BELL SYSTEM PRACTICES
Plant Series

Appendix 1 Section 574-122-800, Issue 4
Teletypewriter Change Notice
TCN 1145 Issue 2
March, 1969
AT&T Co Standard

APPARATUS AFFECTED: All 33 Teletypewriter-Sets (Typing Units)

PART AFFECTED: TP180838 Function Lever (Answer-Back)

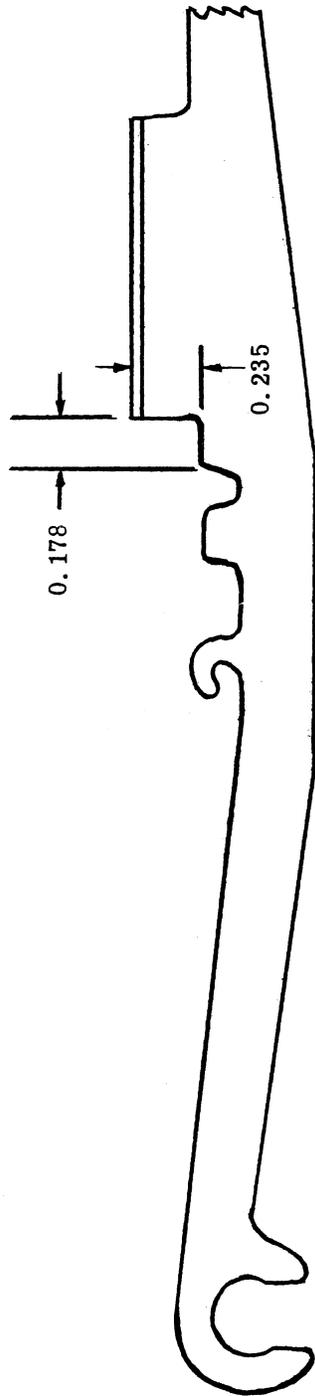
CHANGE: The TP180838 function lever is replaced by the TP186468 function lever.

INTERCHANGEABILITY: The TP180838 and TP186468 function levers are physically interchangeable.

The TP180838 function lever may be modified per dimensions shown on Attachment Sheet 1.

To remove the TP180838 function lever and install the TP186468 (or modified TP180838) function lever, proceed as follows:

- (1) Remove typing unit from set.
- (2) Place typing unit upright and loosen three (3) clamp screws so that TP180782 shaft can rotate freely.
- (3) Unhook TP101386 spring from the TP180838 function lever (slot 15).
- (4) Apply slight upward pressure to TP180838 function lever at a point just to the rear of the shaft.
- (5) Rotate flat side of the TP180782 shaft toward the front of the typing unit very slowly until the TP180838 function lever lifts off.

- (6) Place the open slot of TP186468 (or modified TP180838) function lever over the TP180782 shaft maintaining a slight downward pressure while rotating the shaft toward the front of the unit until the lever falls into place.
- (7) Rotate the TP180782 shaft back to the original position and tighten the three clamp screws.
- (8) Check and remake, if necessary, the answer-back TRIPBAIL POSITIONING adjustment, Section 574-122-700, Issue 3, Page 141.
